Americans with Disabilities Act Accessibility Survey

Self-Evaluation and Transition Plan

Sarpy County Impound Facility

14242 S. 156th St.
Springfield, Nebraska 68159

Sign Height

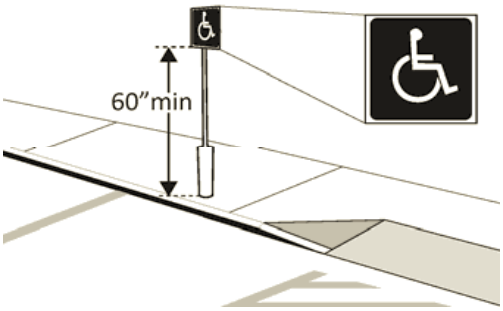
1.10 Are accessible spaces identified with a sign that includes the International Symbol of Accessibility? Is the bottom of the sign at least 60 inches above the ground?

Code	502.6 Identification
Code Description	Parking space identification signs shall include the International Symbol of Accessibility complying with 703.7.2.1. Signs identifying van parking spaces shall contain the designation "van accessible." Signs shall be 60 inches minimum above the finish floor or ground surface measured to the bottom of the sign.
Finding	Accessible space is identified with appropriate sign. Bottom of sign is 44" above the ground.
Compliant?	**NO**
Recommended Repair (if needed)	Raise sign.

Switch 762 Location

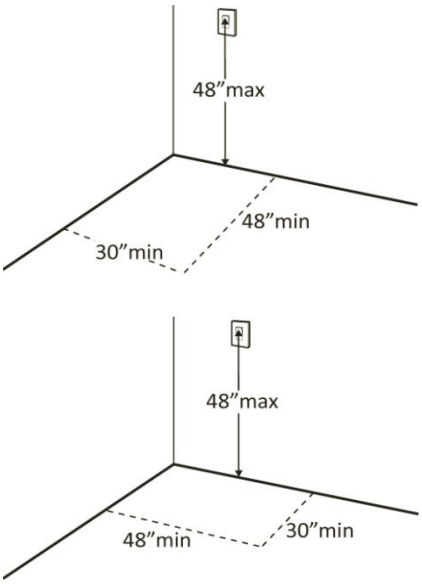
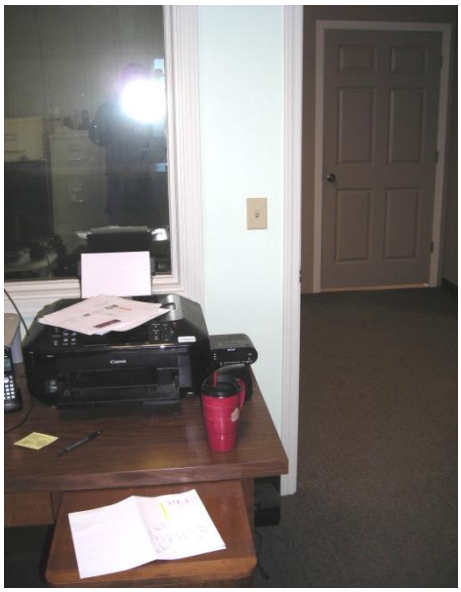
2.50 Continued.

2.43	Doors are not equipped with accessible hardware.	Replace knobs with lever, loop or push hardware.	$2,000.00	2016-05	
2.50	Light switches have insufficient clear floor space.	Remove obstructions or reconfigure walls.	$700.00	2016-05

Soap Dispenser Height

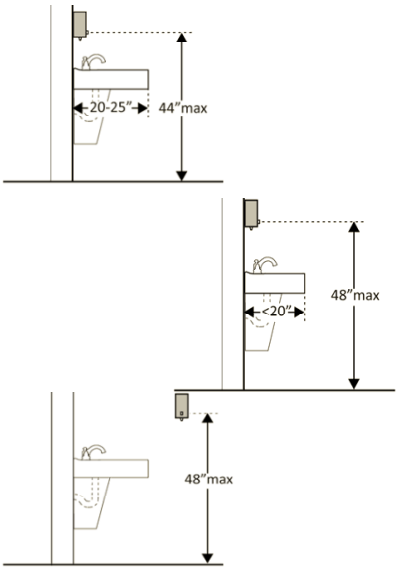
Code	308.1 General
Code Description	Reach ranges shall comply with 308.
Finding	EMPLOYEE RESTROOM: The operable parts of the soap dispenser are 53" above the floor.
Compliant?	**NO**
Recommended Repair (if needed)	Lower soap dispenser.

Towel Dispenser Height

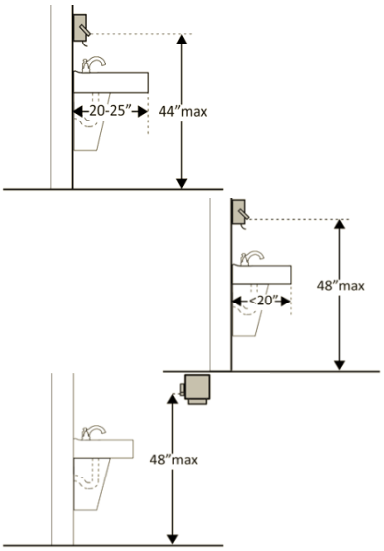
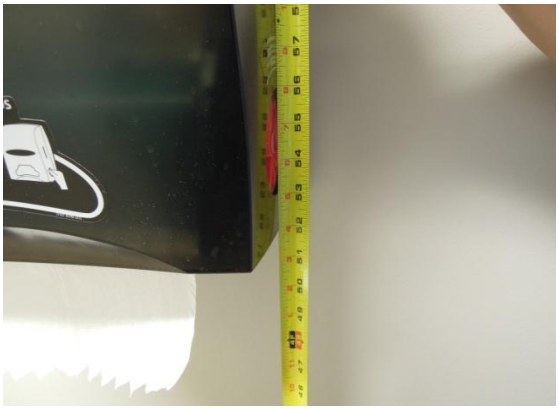
Code	308.1 General; 309.4 Operation
Code Description	308.1 - Reach ranges shall comply with 308. 309.4 - Operable parts shall be operable with one hand and shall not require tight grasping, pinching, or twisting of the wrist. The force required to activate operable parts shall be 5 pounds maximum.
Finding	EMPLOYEE RESTROOM: The operable parts of the towel dispenser are 51-1/2" above the floor. Operable parts require tight grasping, pinching or twisting of the wrist.
Compliant?	**NO**
Recommended Repair (if needed)	Lower/replace towel dispenser.

Grab Bar Length

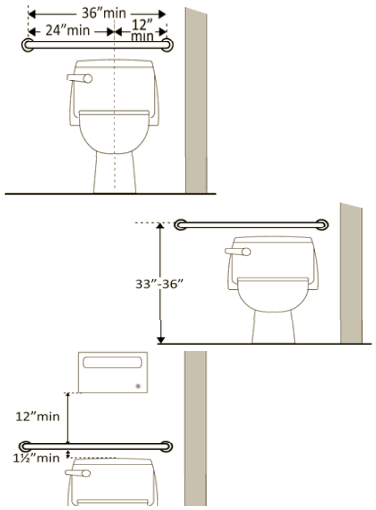
Finding	EMPLOYEE RESTROOM: The grab bar is 36" long on the rear wall, and it extends 20" from the centerline of the water closet on one side. It only extends 18" on the open side. It is mounted 34" above the floor to the top of the gripping surface, and there is 1-1/2" between the wall and the grab bar.
Compliant?	**NO**
Recommended Repair (if needed)	Relocate or replace grab bar.

3.33	Side grab bar doesn't extend far enough; there is insufficient clearance above the grab bar.	Relocate grab bar.	$100.00	2019-03	
3.34	Rear grab bar doesn't extend far enough on open side.	Relocate or replace grab bar.	$100.00	2019-03
